**ADDENDUM NO. 1
TO CONTRACT DOCUMENTS FOR THE
COYOTE WAREHOUSE PROJECT
Project No. 91234002**

Contract No. C0635

Notice is hereby given to Prospective Bidders that the Contract Documents are modified as hereinafter set forth.

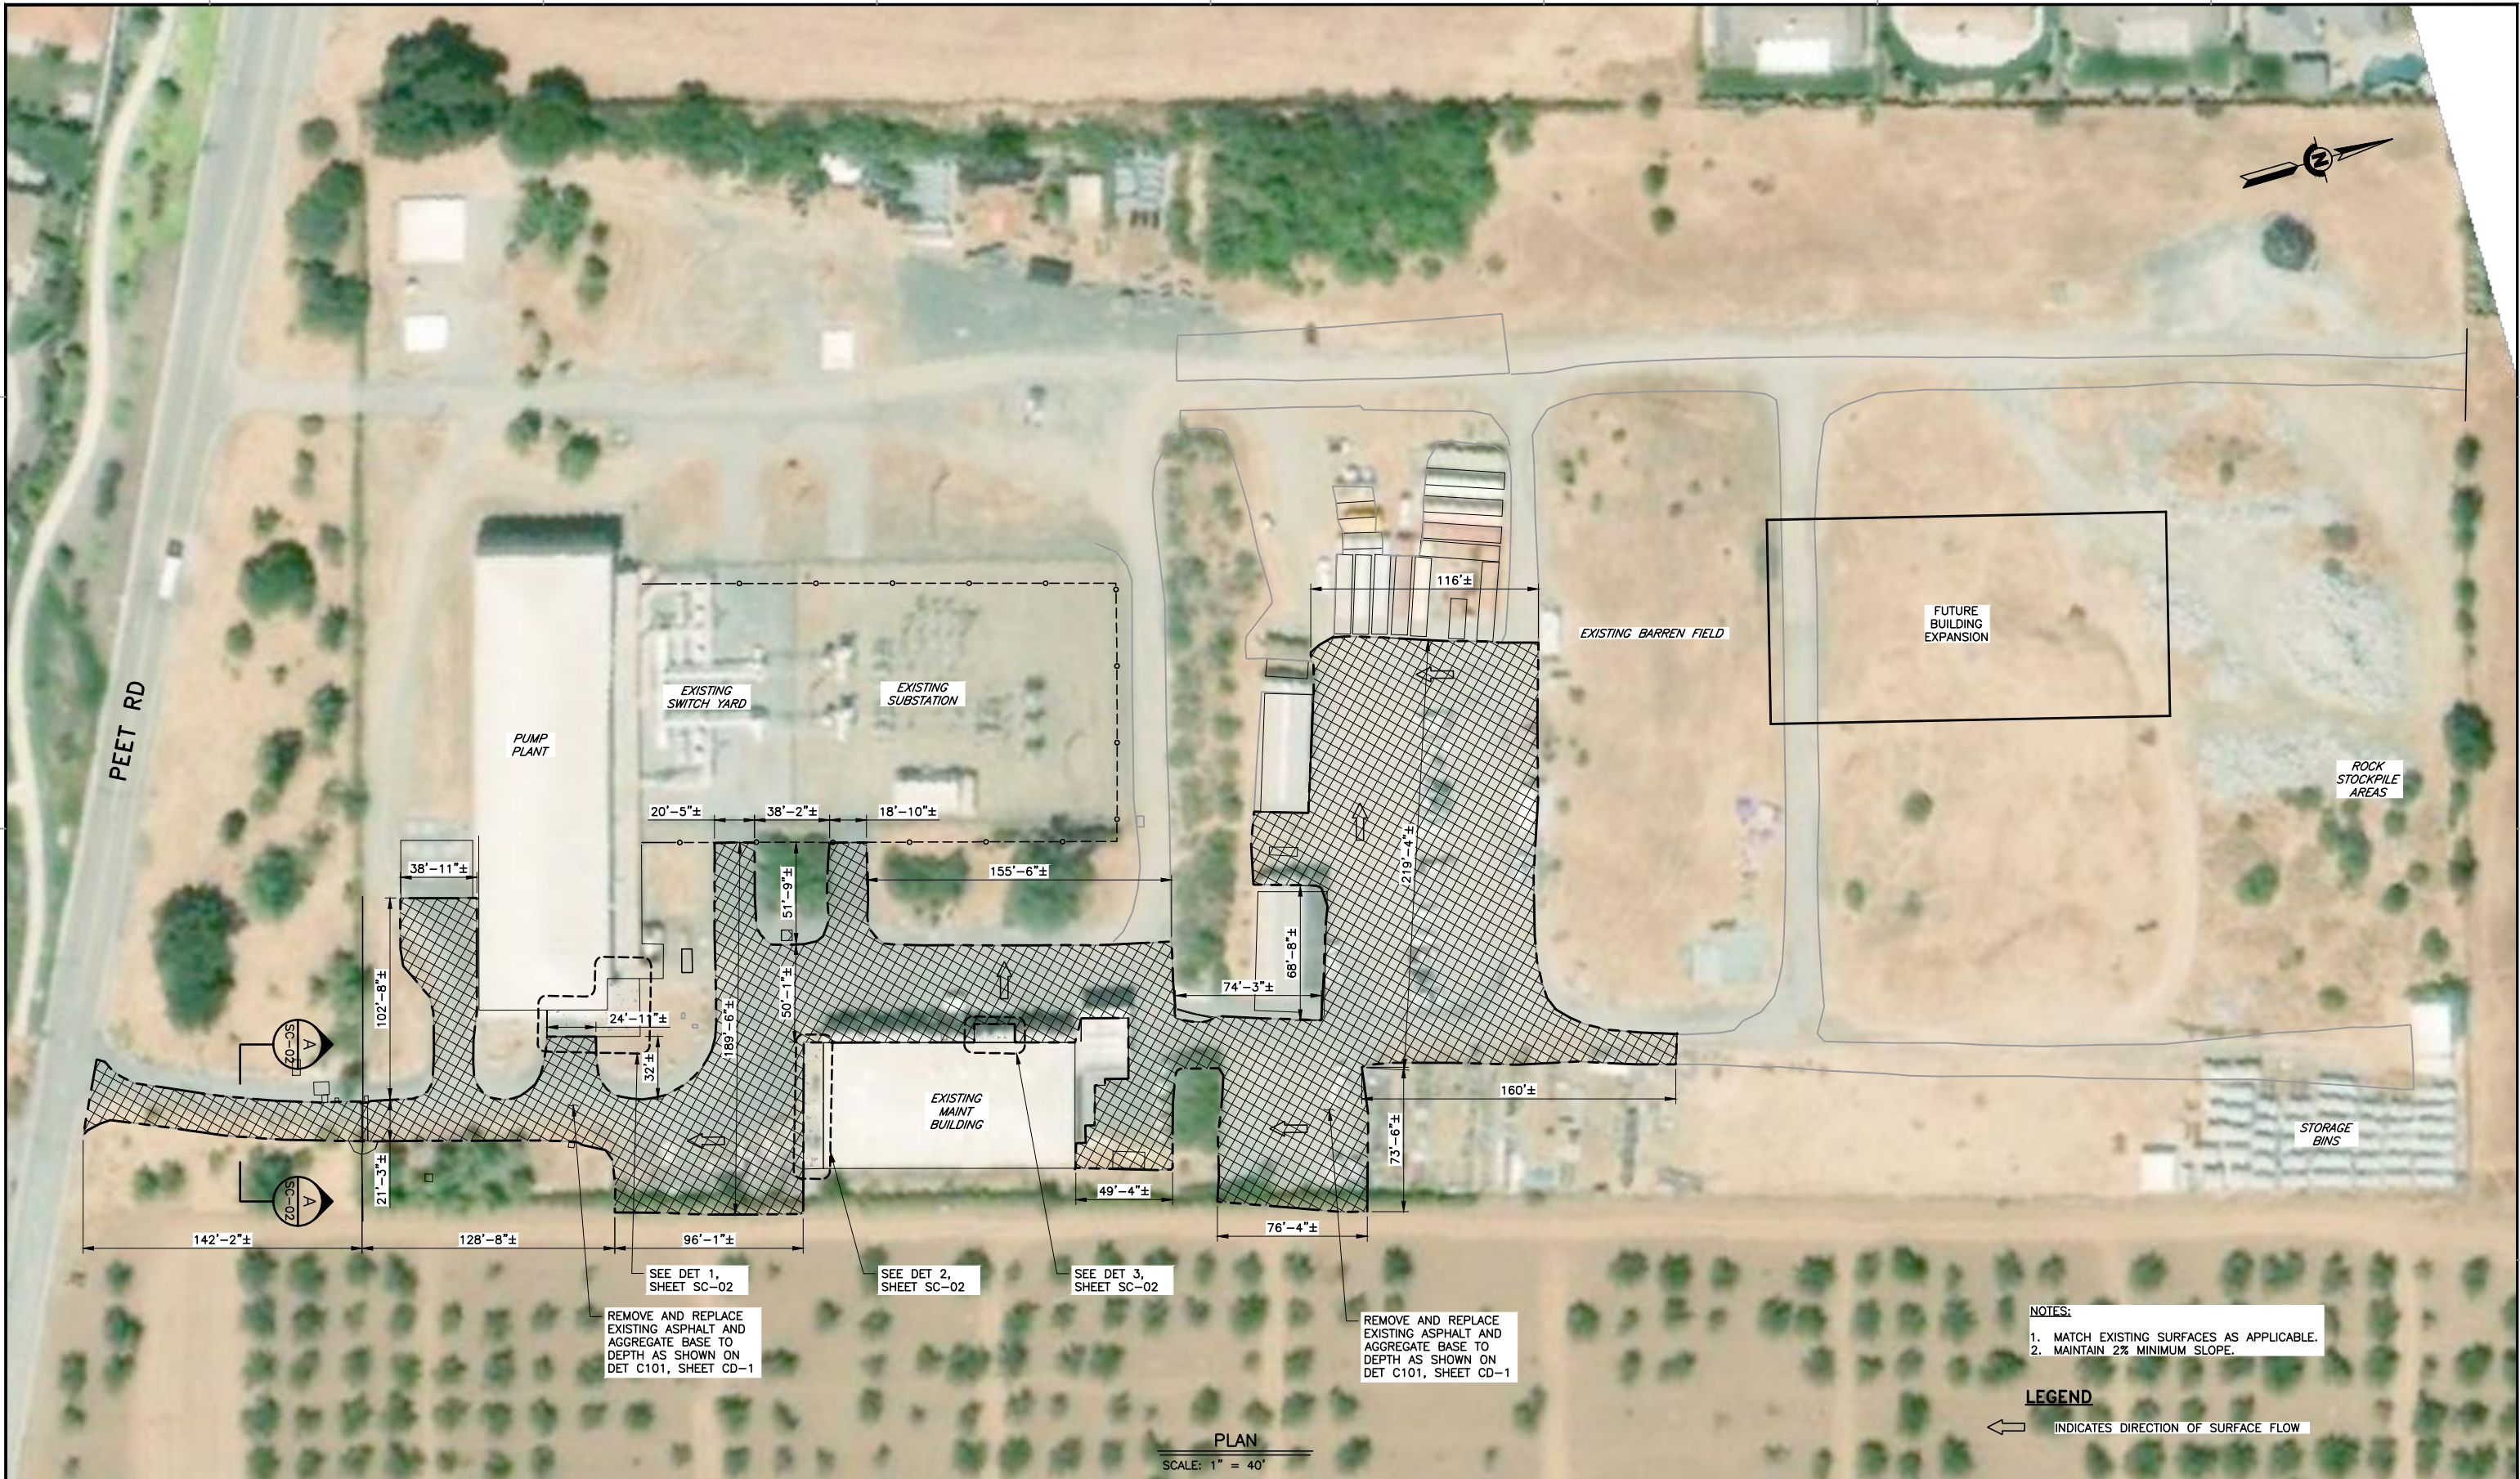
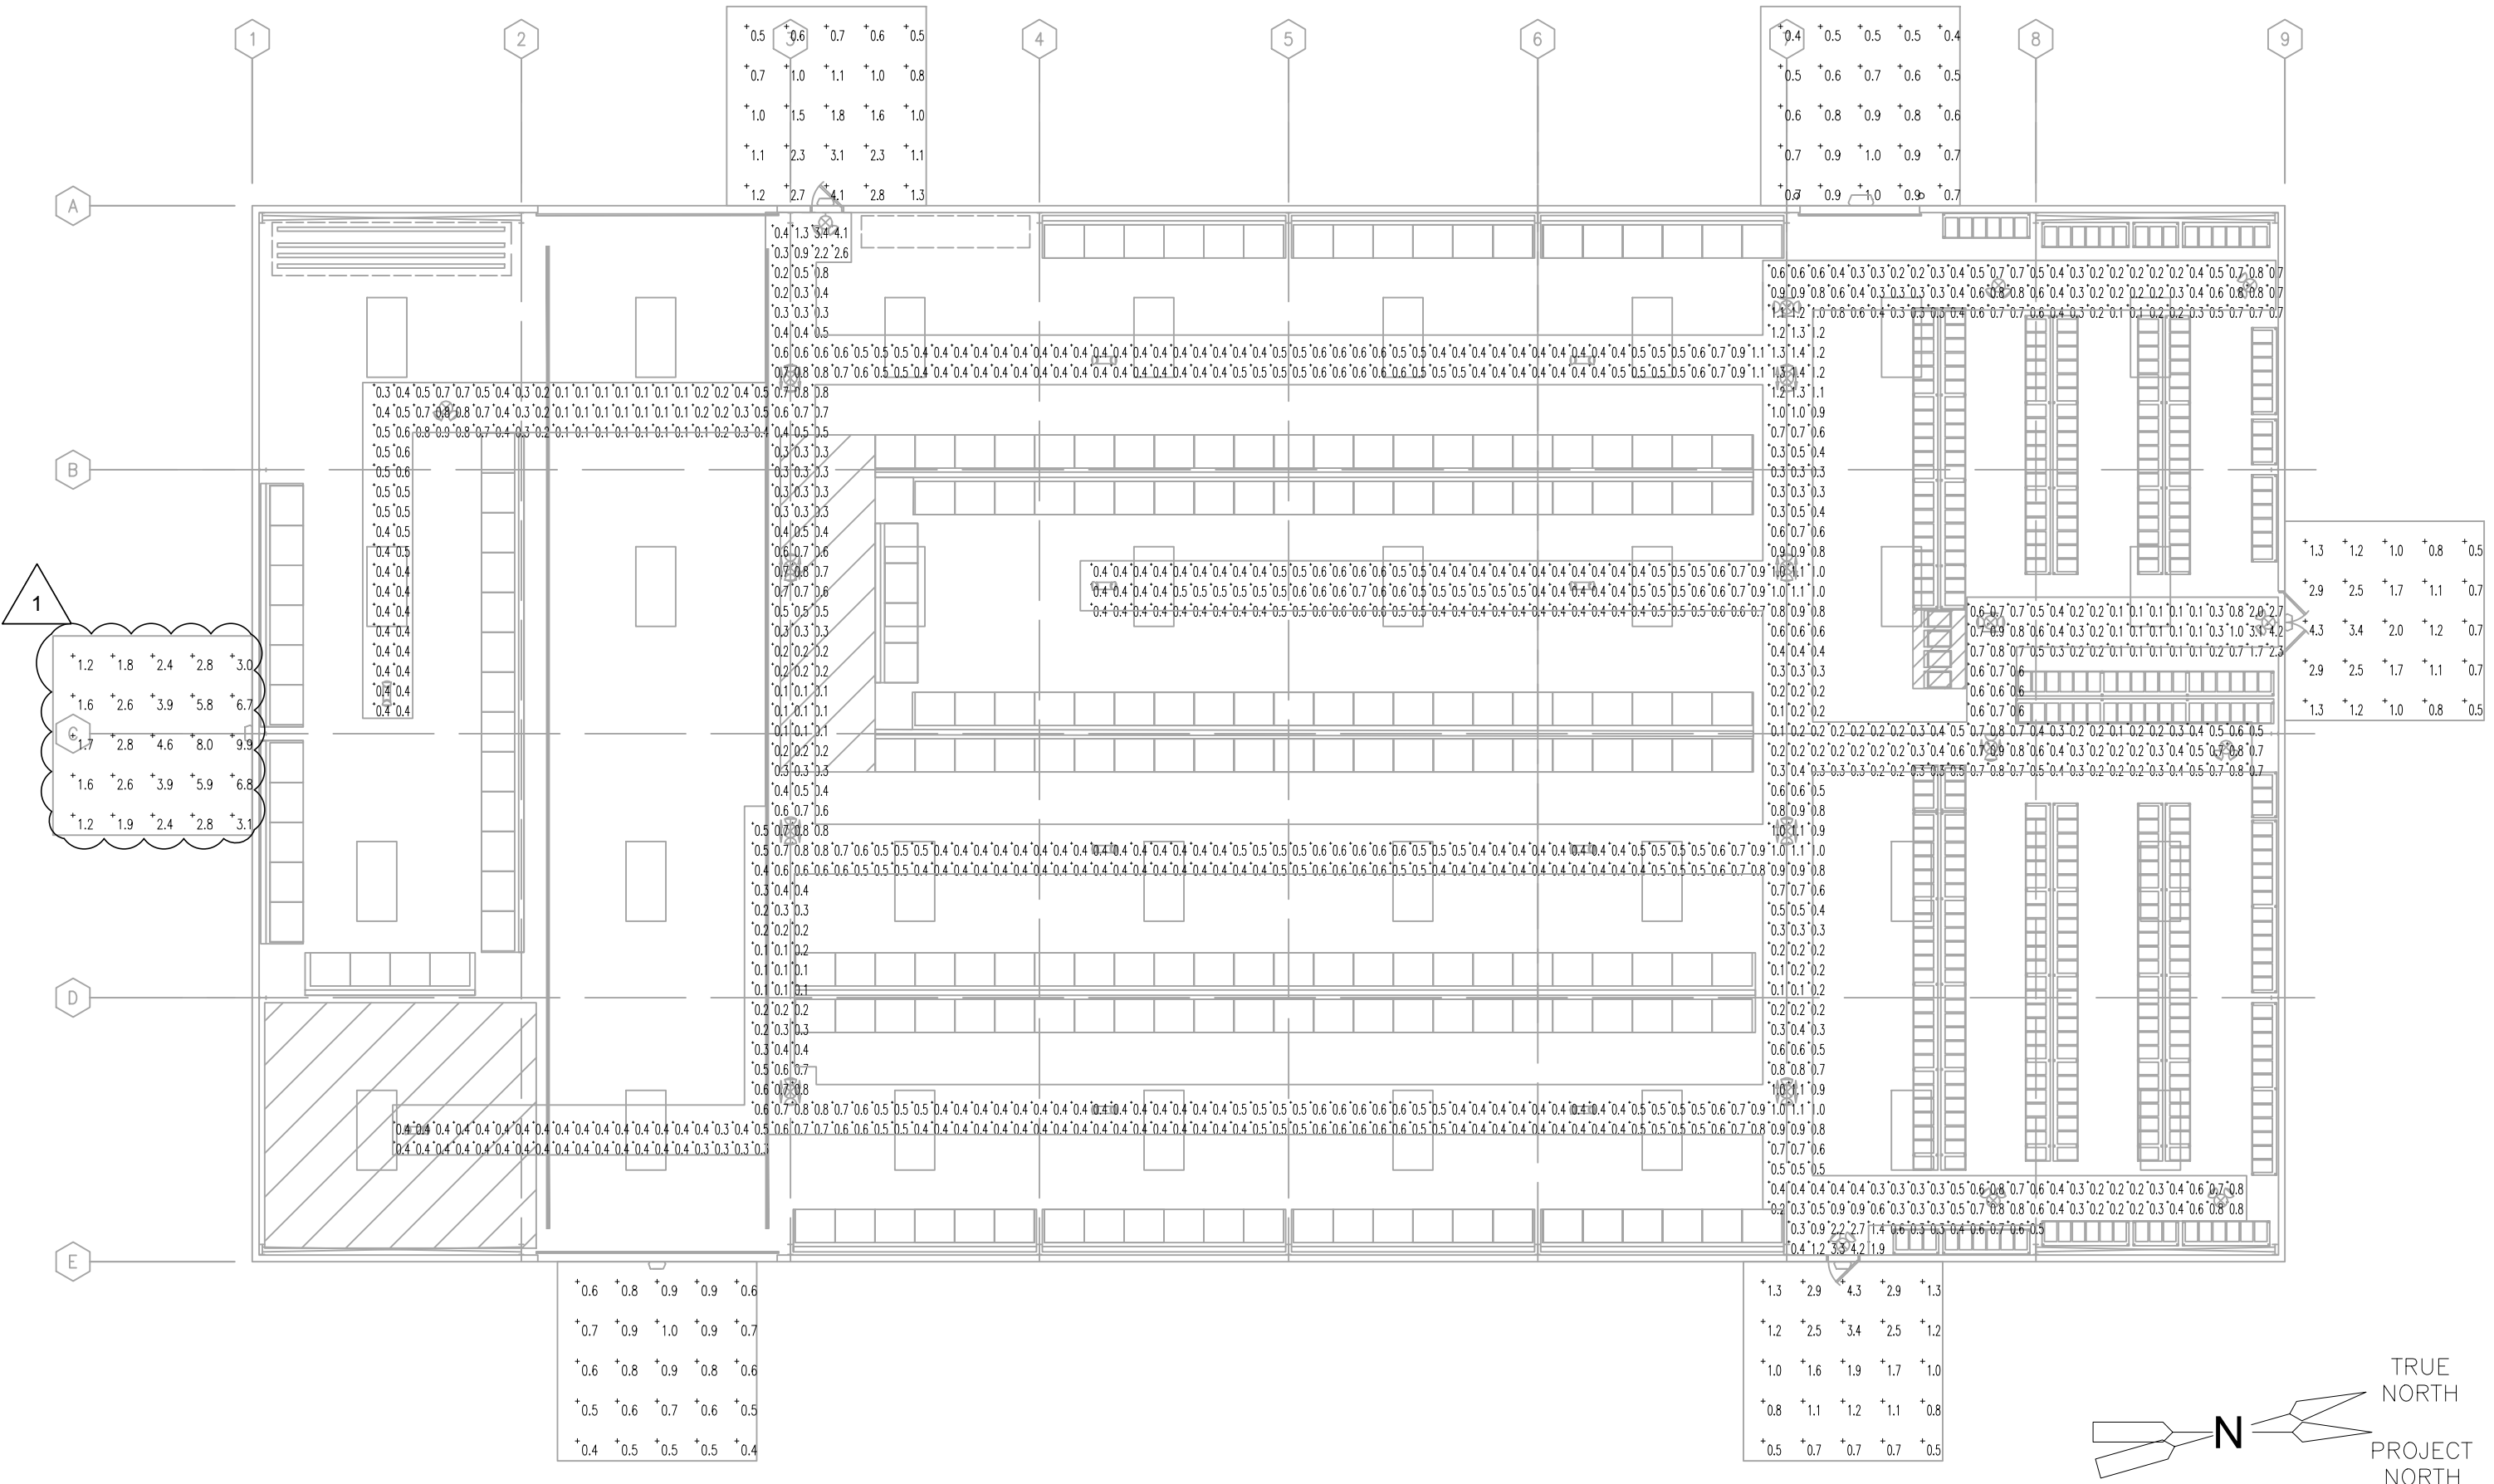
Item no.	Drawing No.	Description
D1-26	SC-01	<u>ADD</u> New Drawing SC-01 ADDITIONAL PAVING SITE LAYOUT AND PLAN. See Attachment E.
D1-27	SC-02	<u>ADD</u> New Drawing SC-02 ADDITIONAL PAVING DETAILS AND SECTION. See Attachment E.
